**Safety Evaluation Report
for the
Safety Analysis Report for Packaging
9977**

S-SARP-G-00001, Revision 2, August 2007

This Safety Evaluation Report (SER) summarizes the review findings for the Safety Analysis Report for Packaging (SARP) for the 9977 B(M)F-96 shipping container. The content analyzed for this submittal is Content Envelope C.1, Heat Sources, in assemblies of Radioisotope Thermoelectric Generators or food-pack cans. The SARP under review, i.e., S-SARP-G-00001, Revision 2 (August 2007), was originally referred to as the General Purpose Fissile Material Package.

Figure 5.3.1 Gamma Source Spectrum

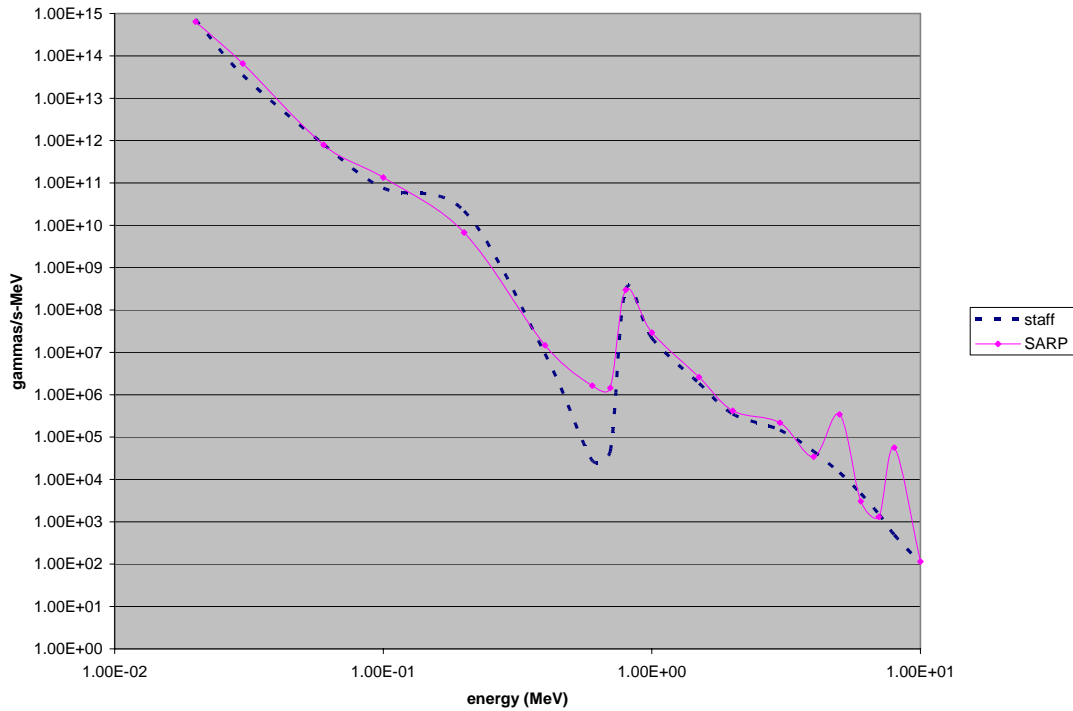
The Staff used ORIGEN-S to determine the gamma source term. A comparison of the gamma source spectrum is presented in Figure 5.3.1.

Figure 5.3.2 Neutron Source Spectrum

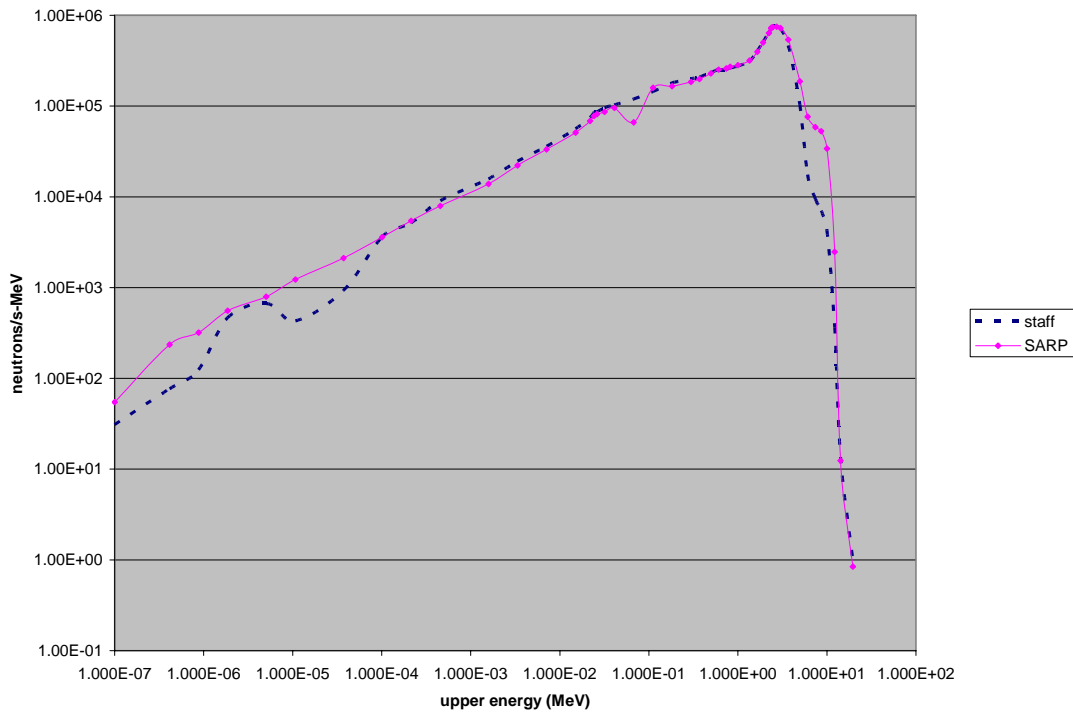
A comparison of the neutron source spectrum is presented in Figure 5.3.2.

The neutron source term generated by the Staff compares well with that in the SARP generated by the applicant, except at low energies and at very high energies (between 6 and 12 MeV). The SARP data shows larger populations at these energies. However, the discrepancy in the low energy region is not significant. In the most important region of the spectrum, between 0.1 MeV and 6 MeV, the agreement between the two independent calculations is good (within 10%). The

overall source strength calculated by the Staff is 1.86×10^6 neutrons/s, compared with 2.24×10^6 neutrons/s calculated by the applicant, leading to a 20% conservatism in the applicant's neutron source term.
